# **STRUCTURAL BARN EVALUATION**

**243 POST ROAD  
BOWDOINHAM, MAINE 04008**

Project No. 20-0377-ME

Criterion Engineers is pleased to provide a structural evaluation of the building located at 243 Post Road in Bowdoinham, Maine. This building was built as a 3-story chicken barn around 90 years ago, was extended to the back shortly thereafter with a similar construction, and has been in used for storage and as the Town of Bowdoinham's Recycling Barn for 30 years. The building also includes one rental apartment on the third floor. The floor loading capacity, and the structural strength of the roof, has been evaluated by various structural engineers. This evaluation is to provide a second opinion.

Rafter Beam,  
MODIFIED

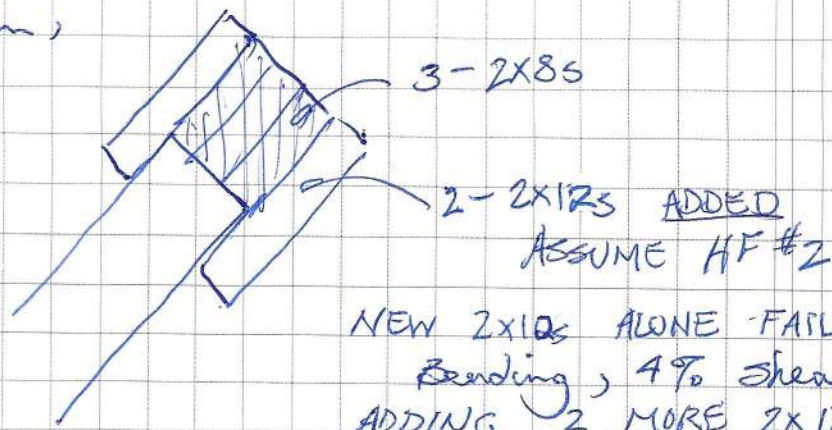
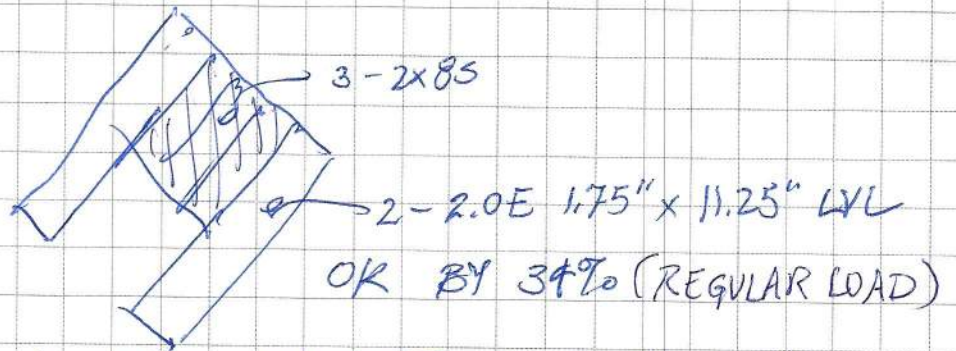
NEW 2x12s ALONE FAIL BY 58%  
Bending, 4% Shear  
ADDING 2 MORE 2x12s FAILS IN  
BENDING BY 16%

RAFTERS @ 8' WORKS BY 25% (REGULAR LOAD)  
RAFTERS @ 9' WORKS BY 6% ( " " )  
UPPER RAFTERS NEED TO BE SIZED FOR UNBALANCED LOAD.

RAFTER BEAM: ADD 1 LVL EA. SIDE OF BEAM - SIZE FOR  
ADDITIONAL LOAD OF UNBALANCED SNOW.

**BOWDOINHAM RECYCLING CENTER**  
**RECYCLING CENTER BUILDING MODIFICATIONS**

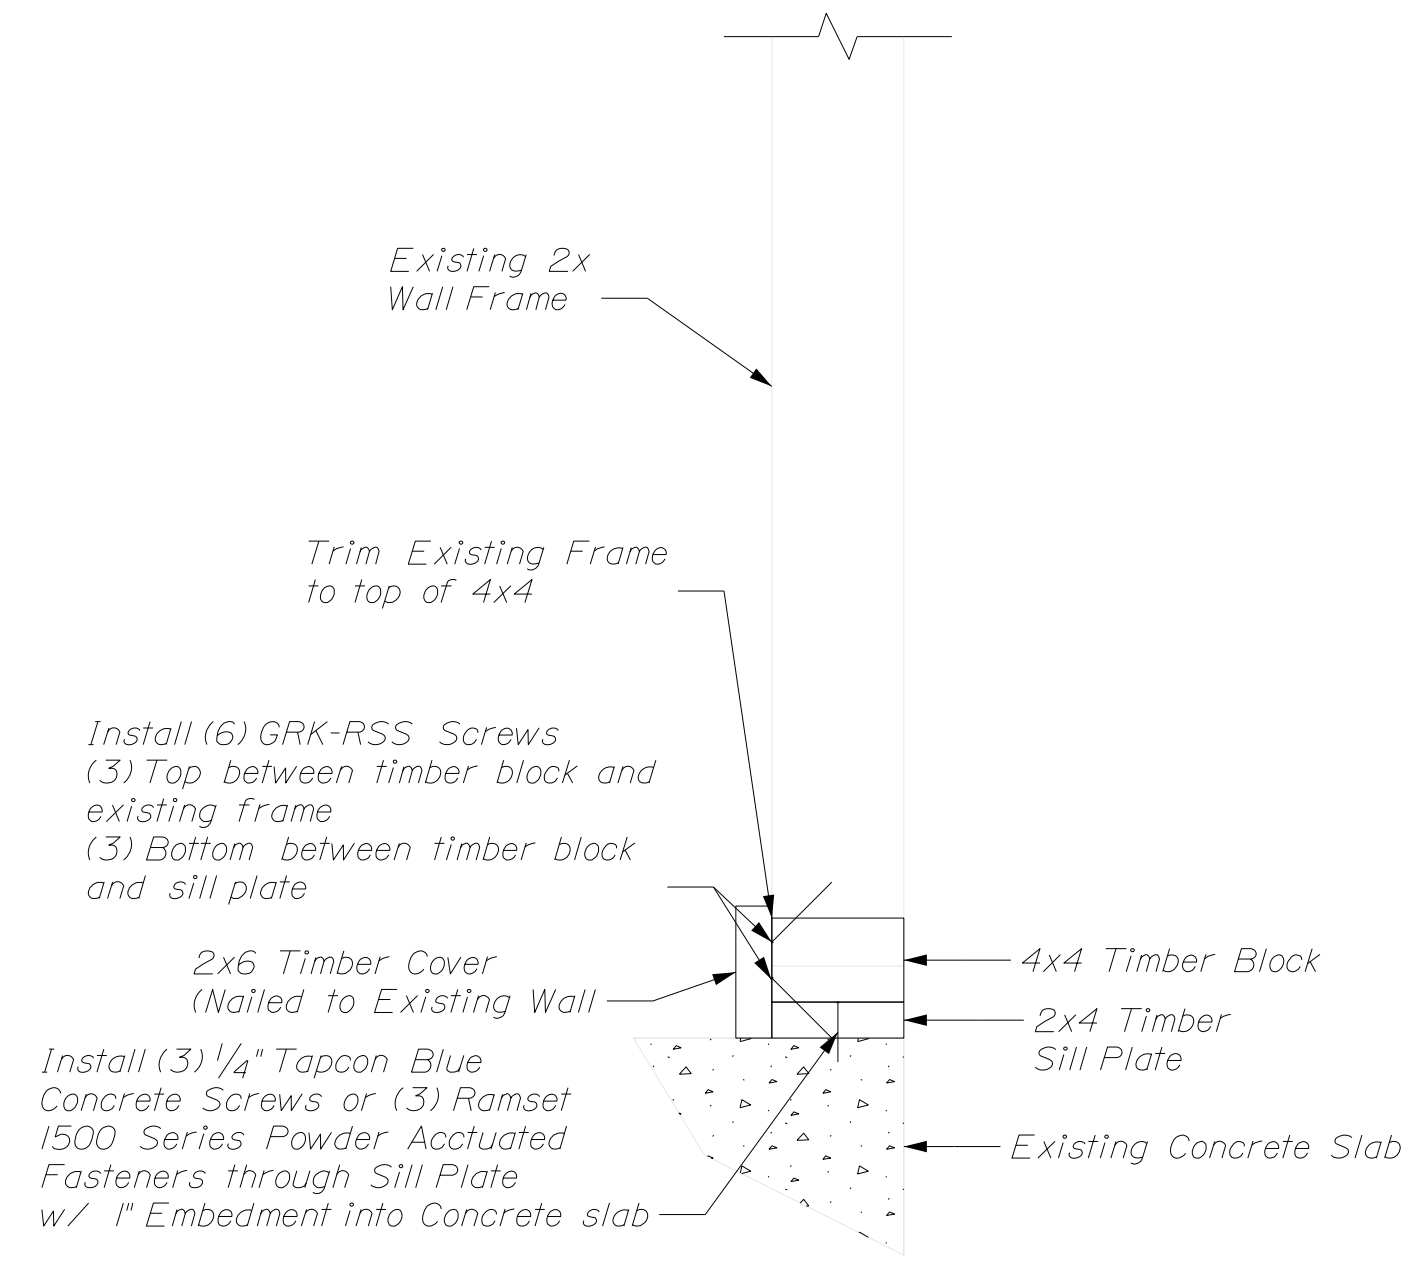
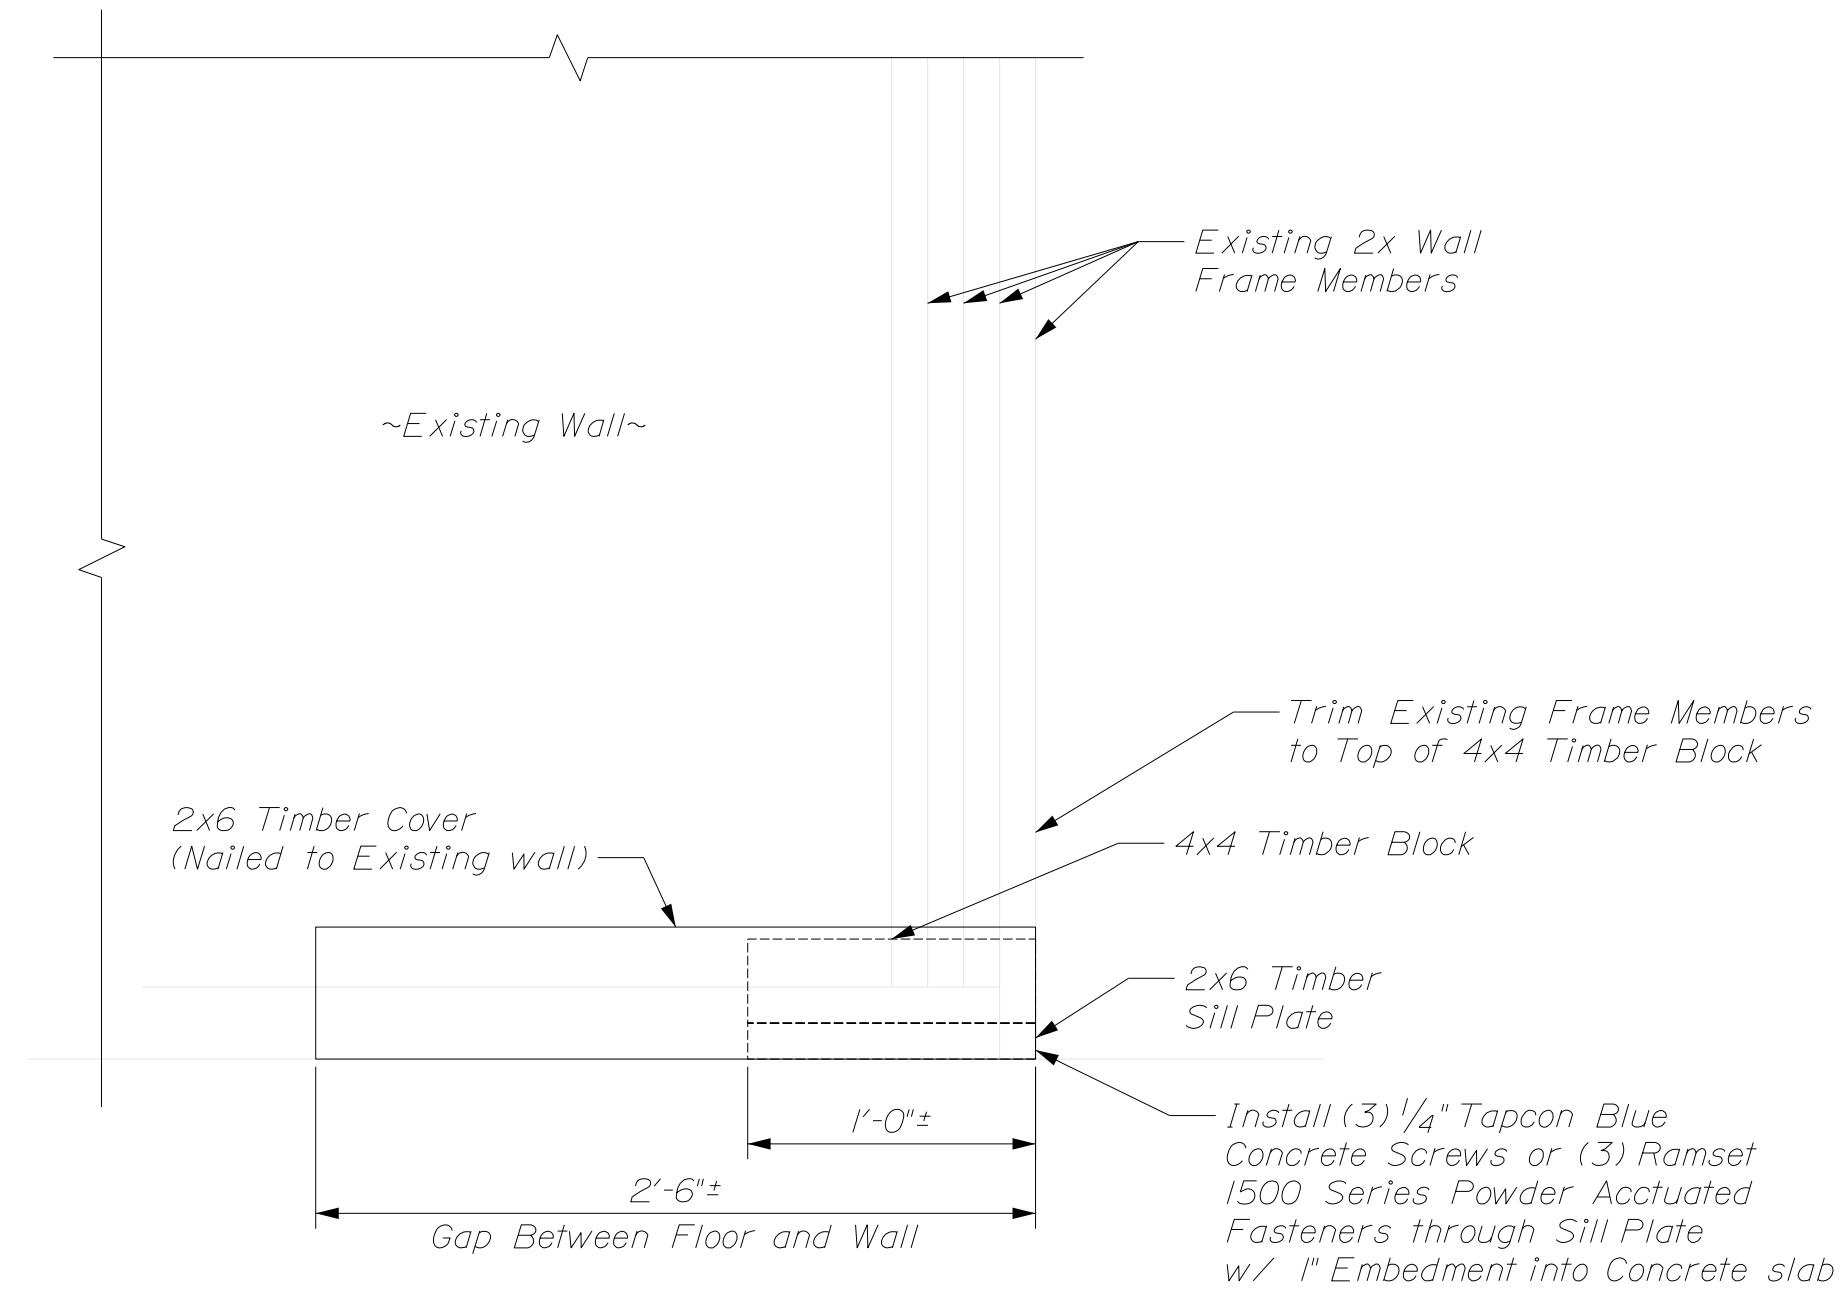
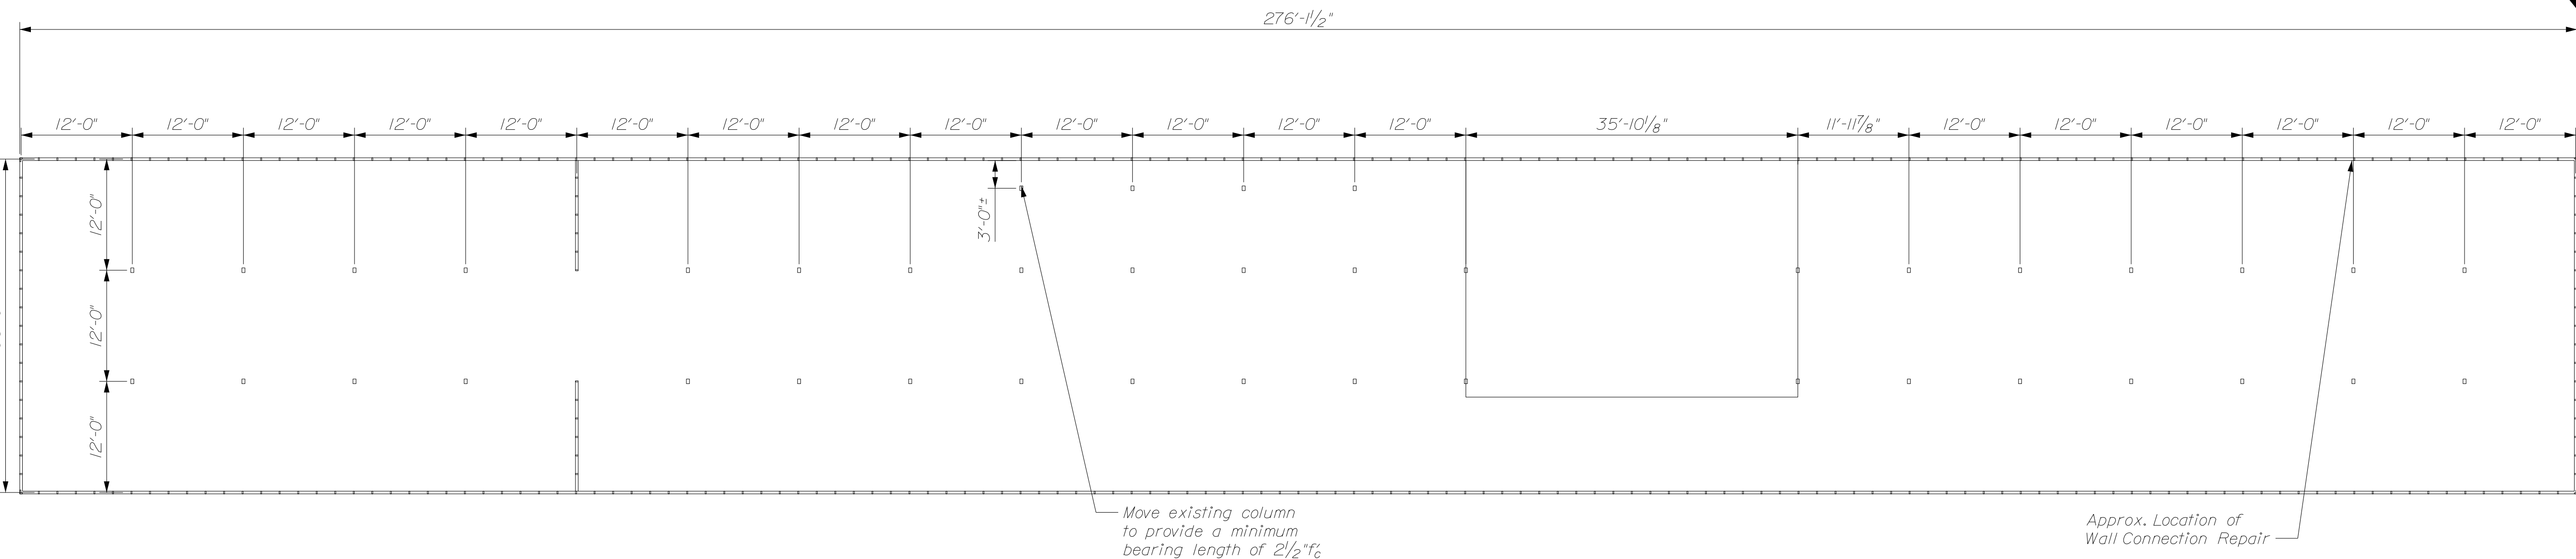
The CE design shows adding one 1.75"x11.25" Versalam to the beam supporting the rafters. I calculated the need for two Versalam beams; I assumed that the stronger and deeper material would take all the load from the 2x8s because the lower edge of the engineered lumber is taking the tension below the bottom of the 2x8s. This calculation should be checked.

The CE design for the trusses uses some 1" diameter A325 bolts. These connections work well for steel-to-steel applications, but a steel-to-wood application should use more, smaller, connectors rather than one, larger, connector, to prevent wood failure at the joint.

The extensive repairs recommended for the large trusses at the east end of the building may be more simply addressed by installing a steel beam in these two locations, supported by the 12x12 columns as needed.

CE's inspection noted some damage to studs and lack of connection between the building and the foundation in one area. Repairs should be made per the Calderwood report.
